Town of Surfside

Champlain Towers South Memorial Project

Addendum No. 2

Bid Questions

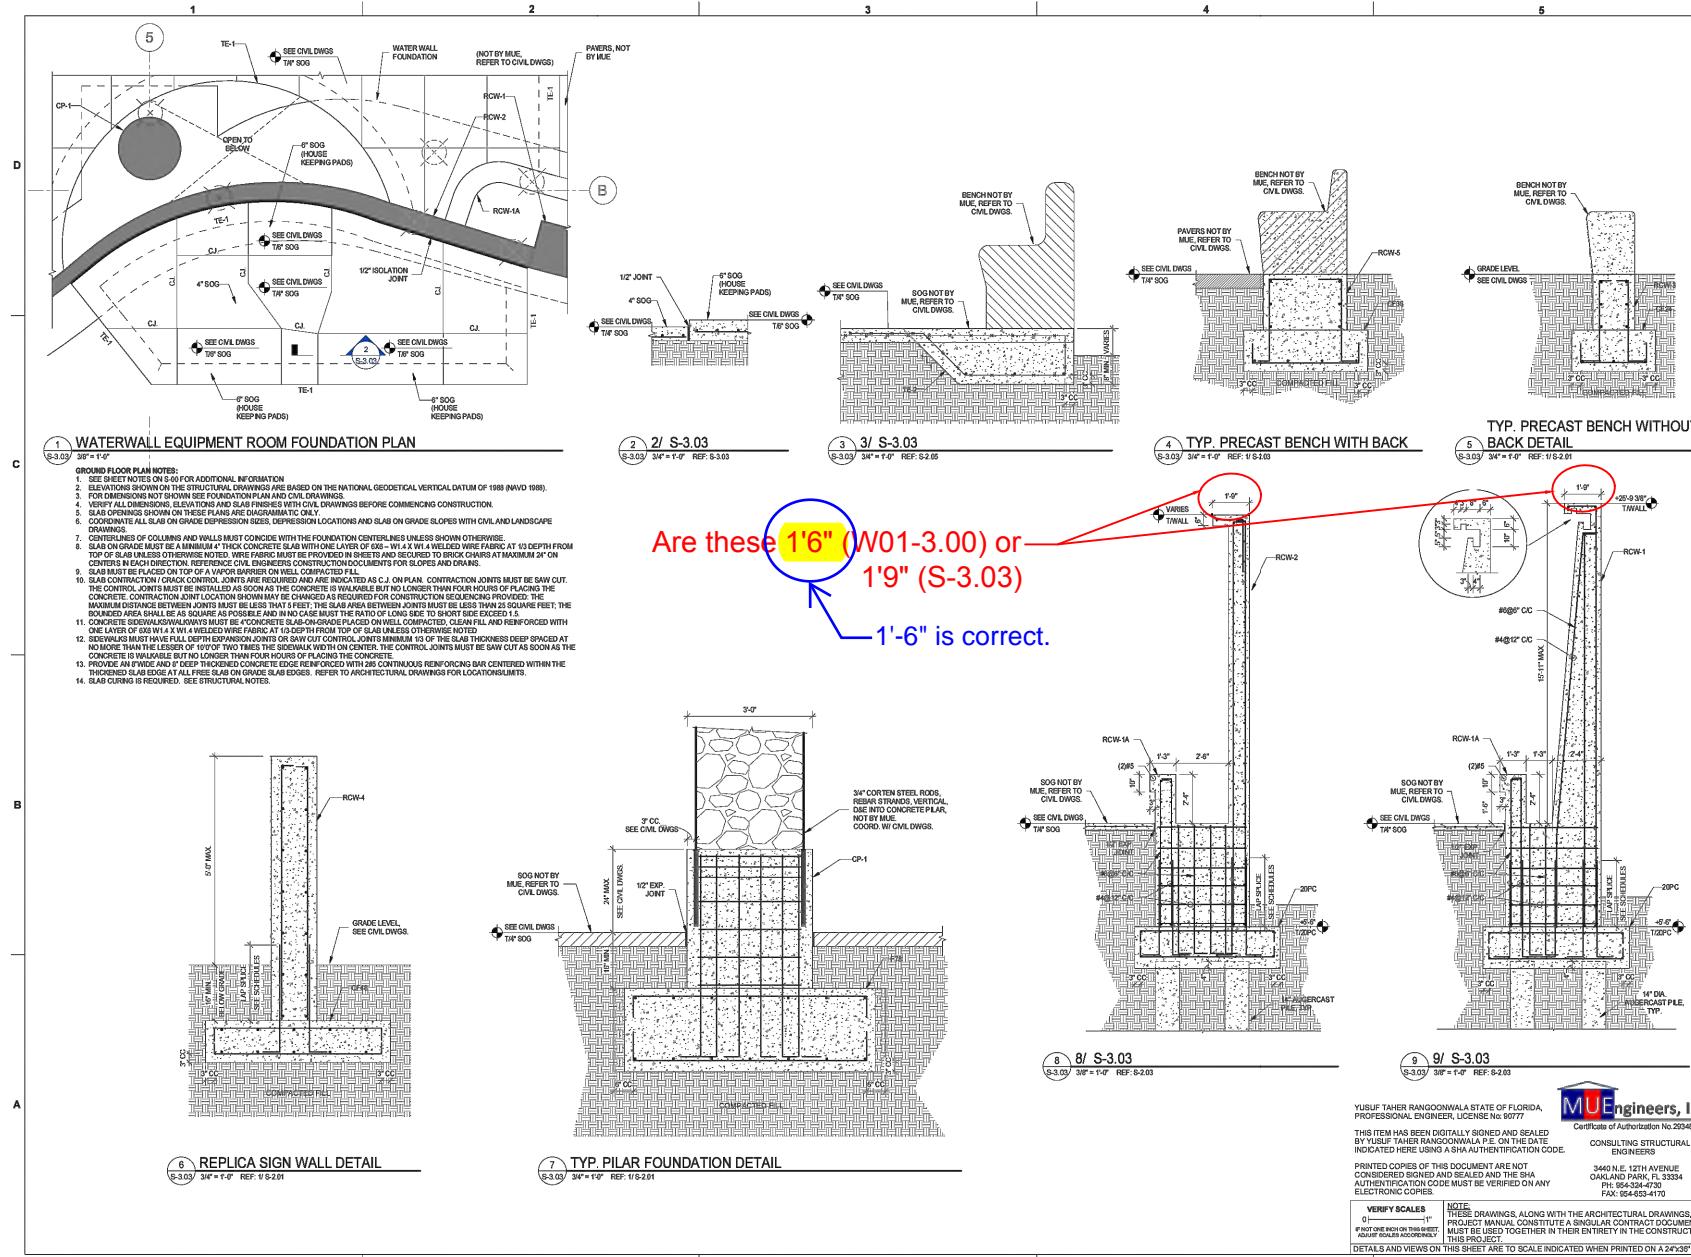
40. Please provide the surface area of the dome / canopy shell that will receive shotcrete or provide 3d Model if available.

Response: Surface area of the canopy dome structure (to top of pile cap) to receive shotcrete is roughly 5300 sf. Note - the extent of this surface area is graphically identified as the "Dome Structure" on 2/S-2.00. Upon award of contract, the 3D Model may be provided to the contractor for use in verification, shop drawings and construction.

SHEET NUMBER W01-3.00
PROJECT NUMBER 13784.00
STATUS: FOR PERMIT

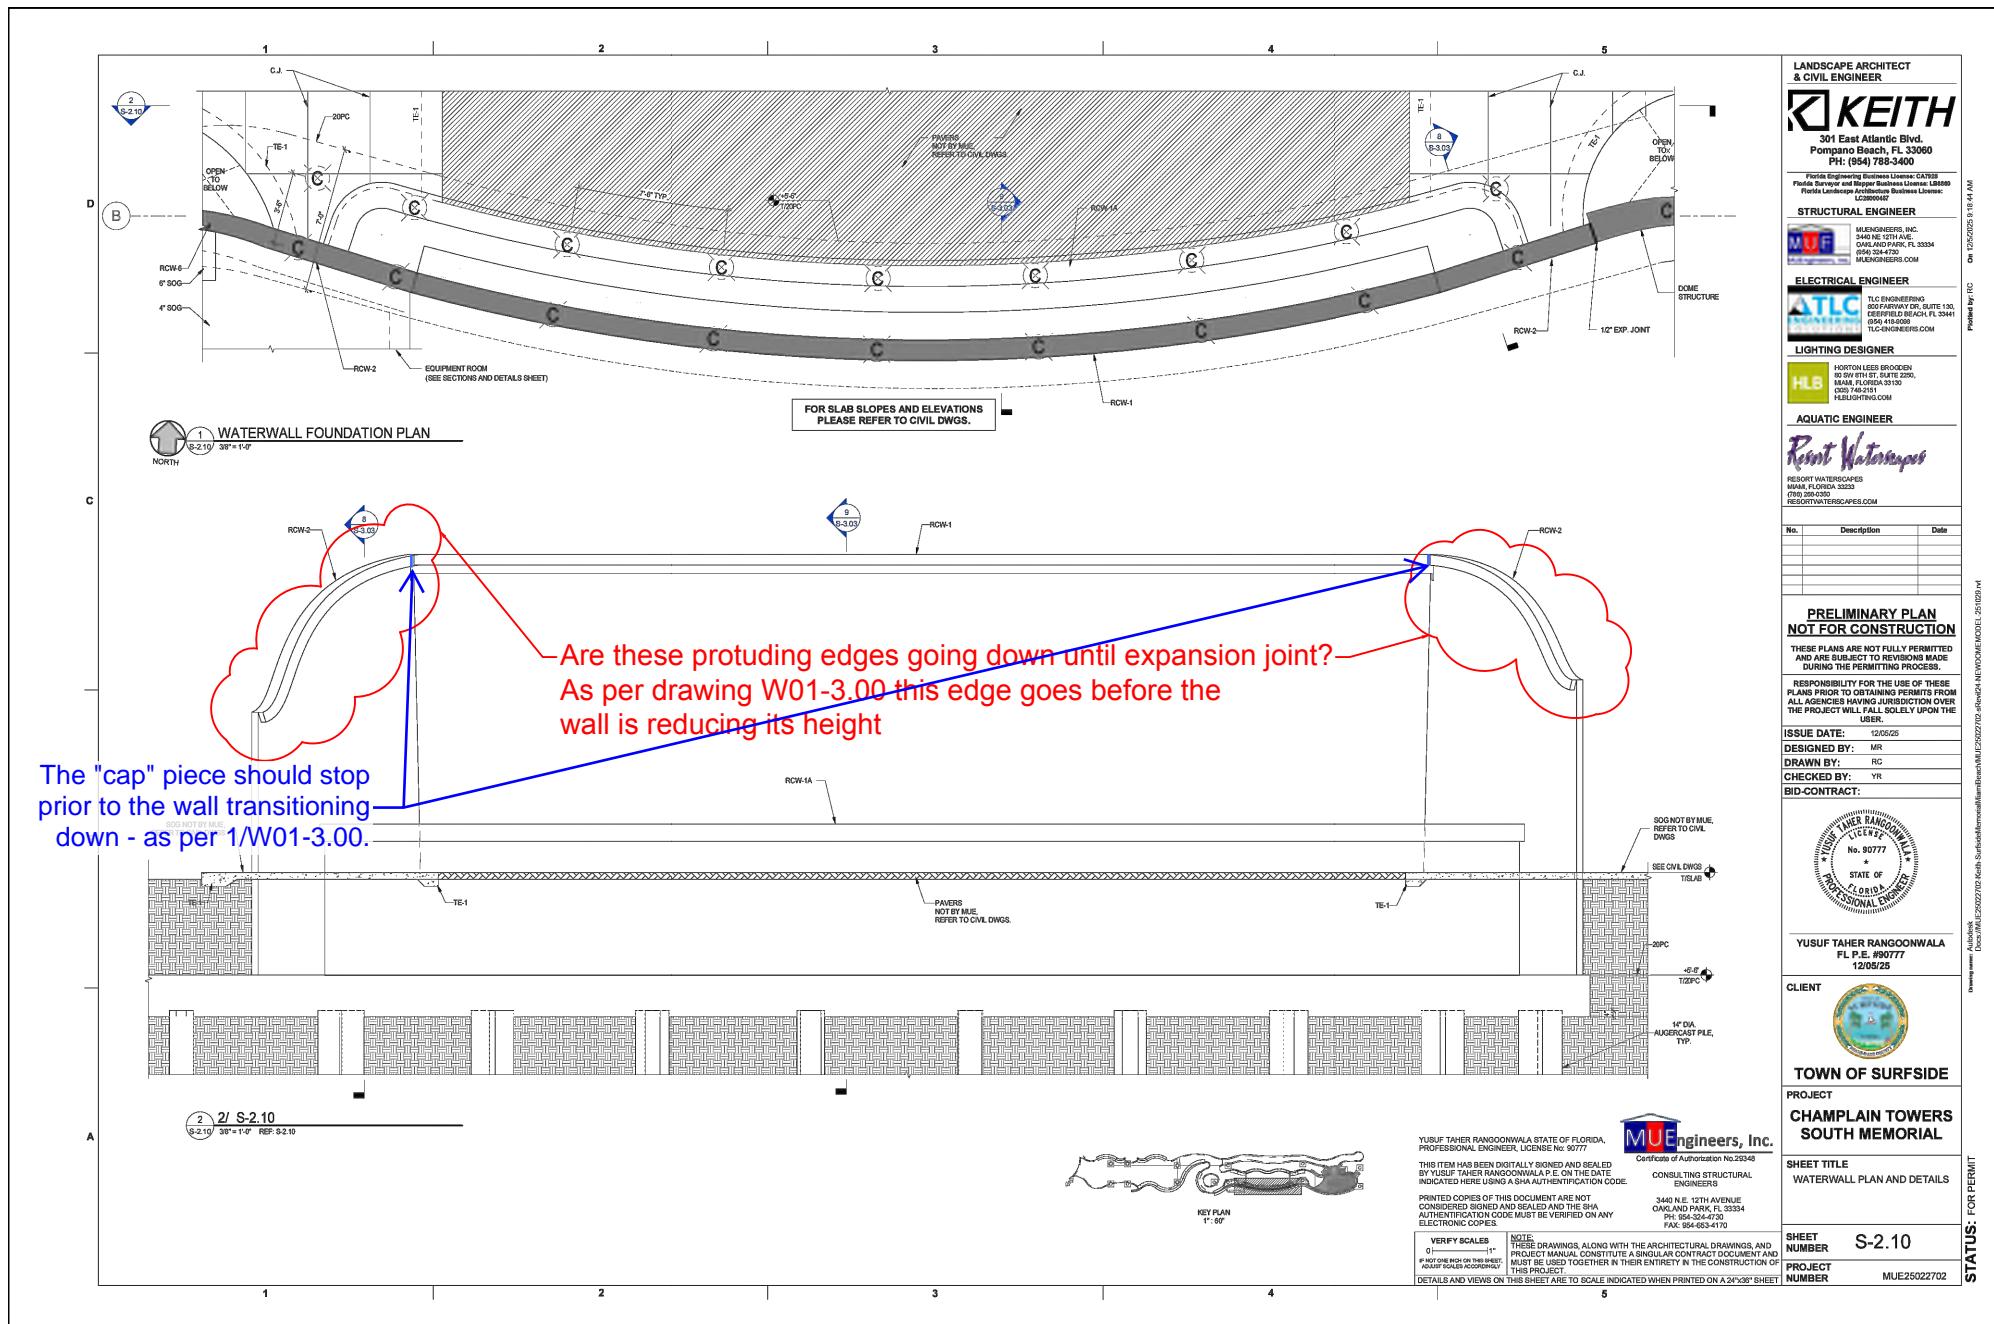
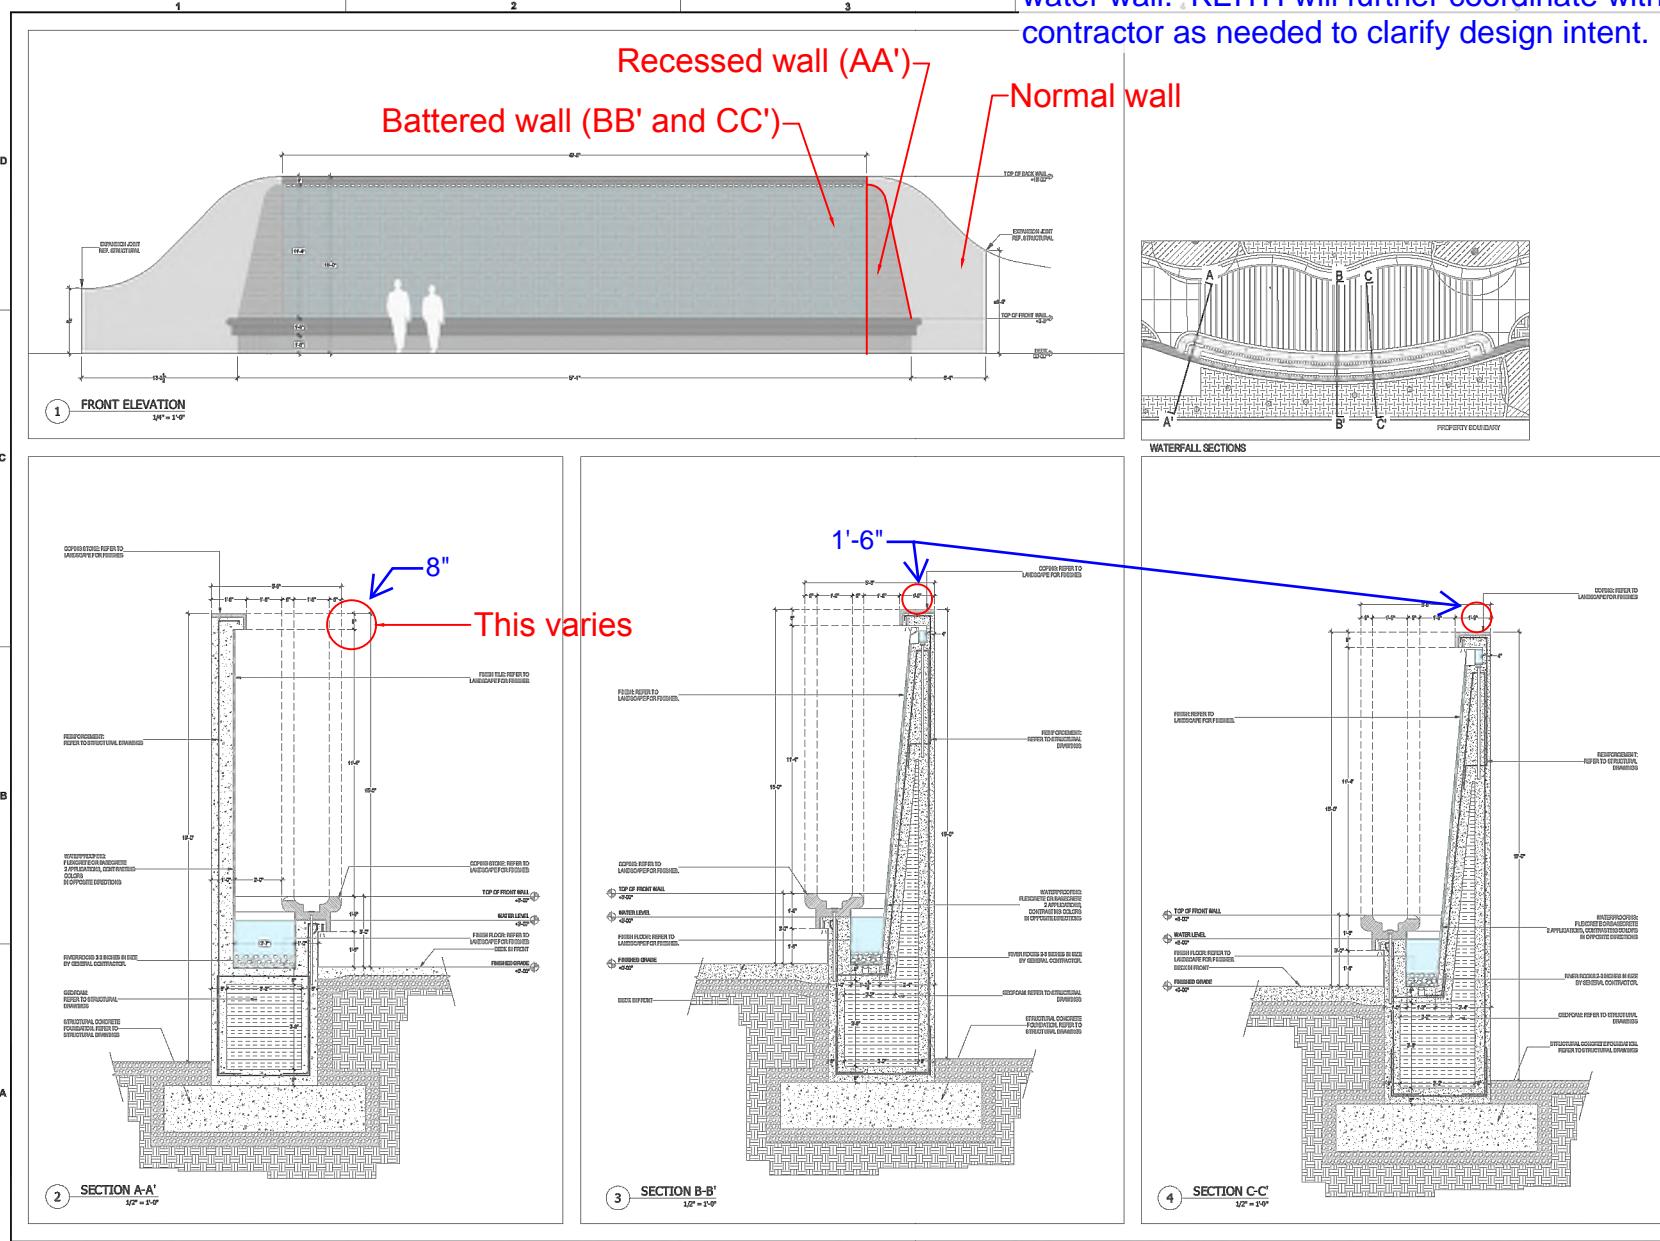
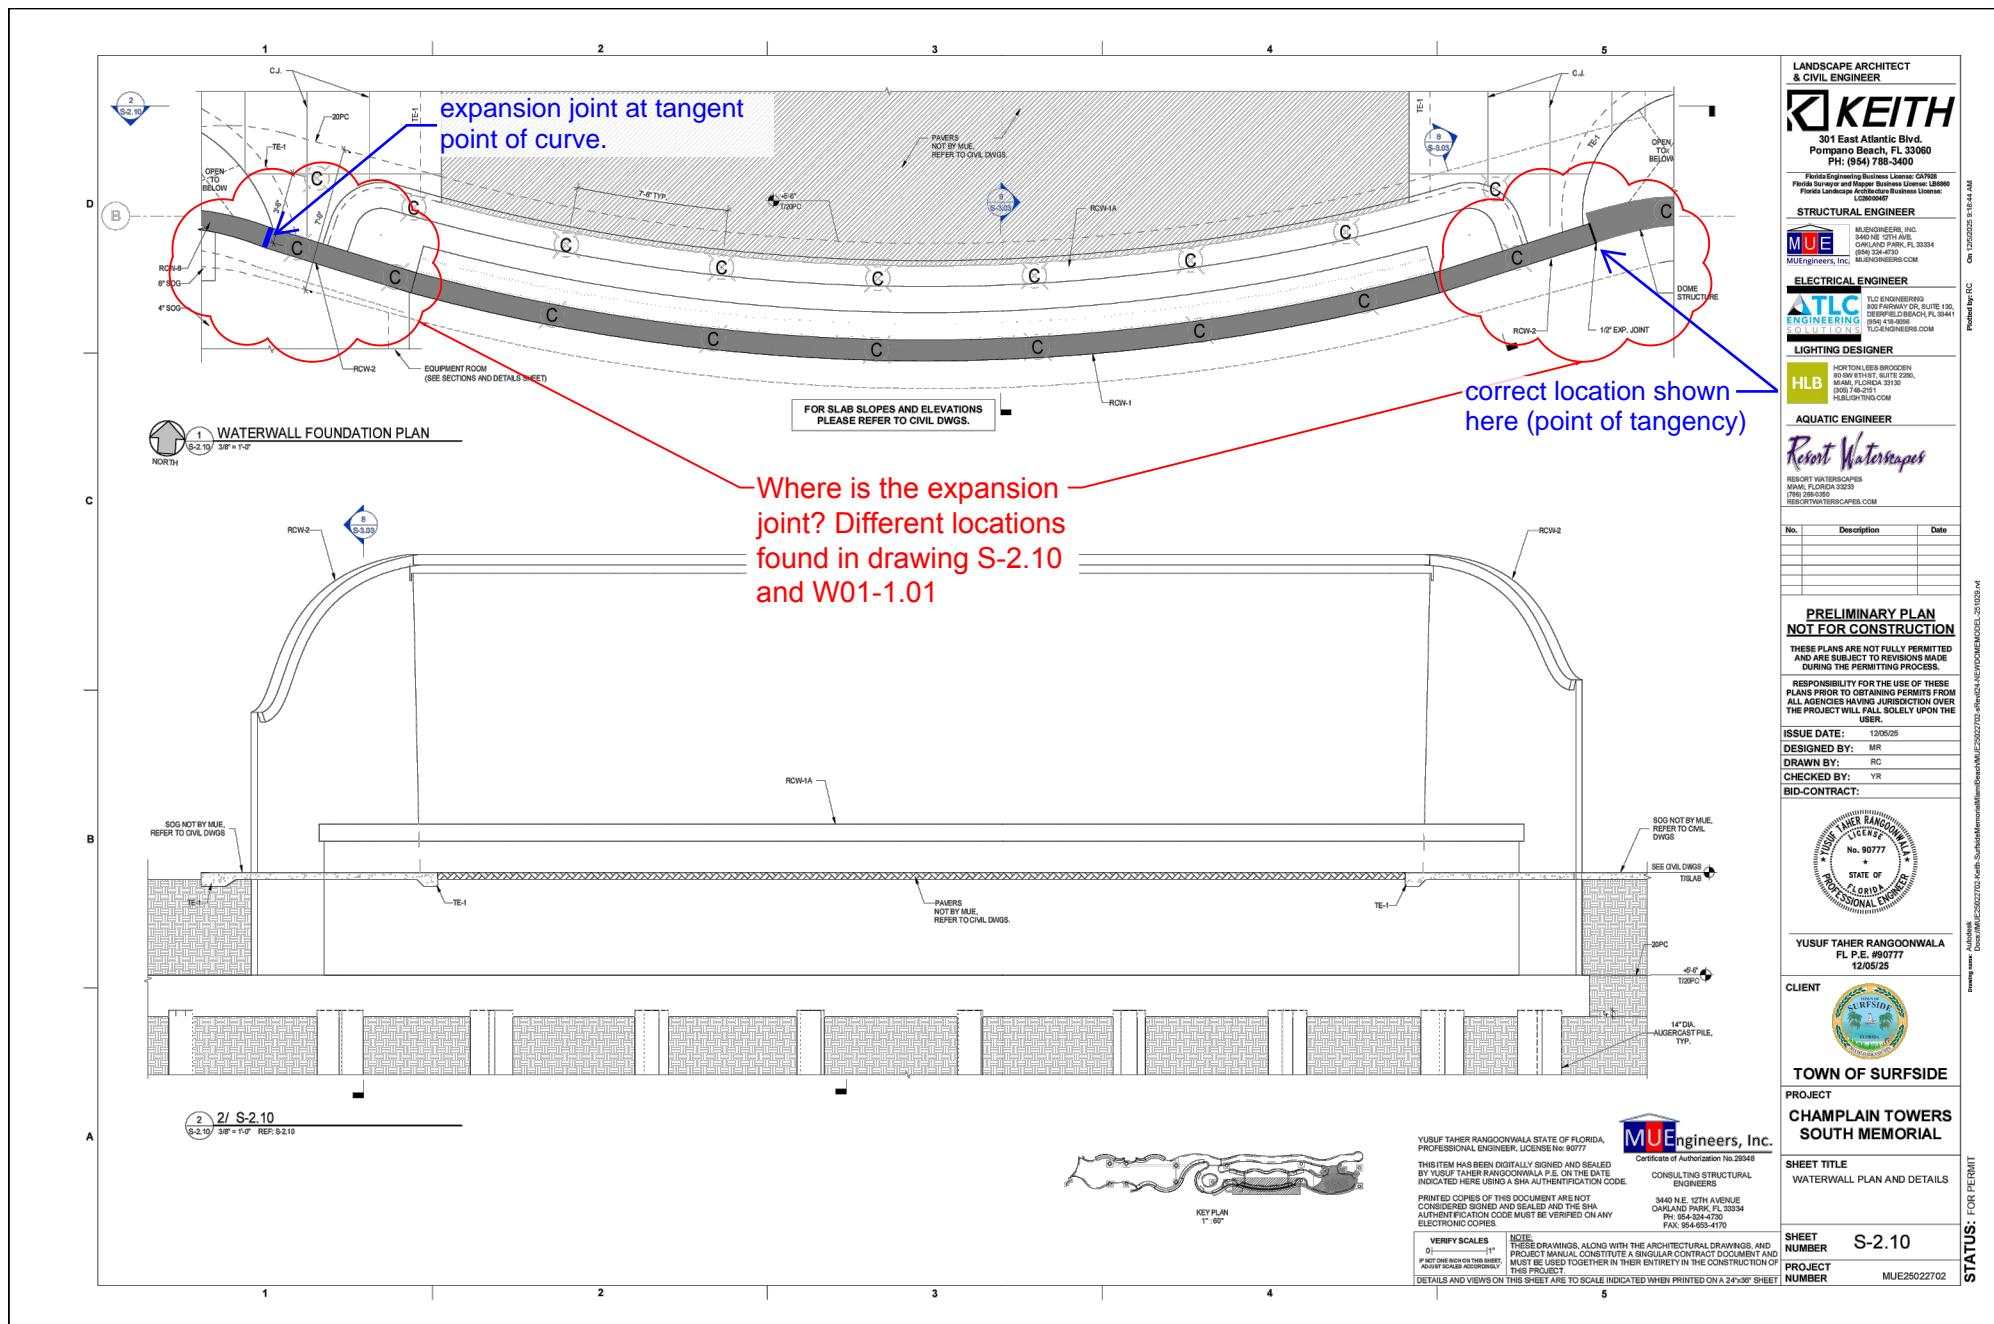
38. Clarify wall sections of the waterwall (RCW-1 and RCW-2) on plans S-3.03 and S-2.10. Plan S-3.03 does not correspond to W01-1.02, which appears to change dimensions and section type.

BidRFI #38

Are these 1'6" (W01-3.00) or—
1'9" (S-3.03)
1'-6" is correct.

- **Wall "cap" should be overall 1'-6" width (inclusive of cap), 8" height per W01-3.00 and 3/LH-504.**

- **Wall "cap" or protruding edges should stop prior to the wall transitioning down - per 1/W01-3.00.**
- **"Normal" wall adjacent to water wall will have a batter (artistic shotcrete topping) that tapers to meet the batter of the water wall. KEITH will coordinate with awarded contractor and provide 3D model as needed to further clarify design intent.**
- **Response noted in blue on RFI plan markup.**

"Normal" wall adjacent to water wall will have a batter (artistic shotcrete topping) that tapers to meet batter of water wall. KEITH will further coordinate with awarded contractor as needed to clarify design intent.
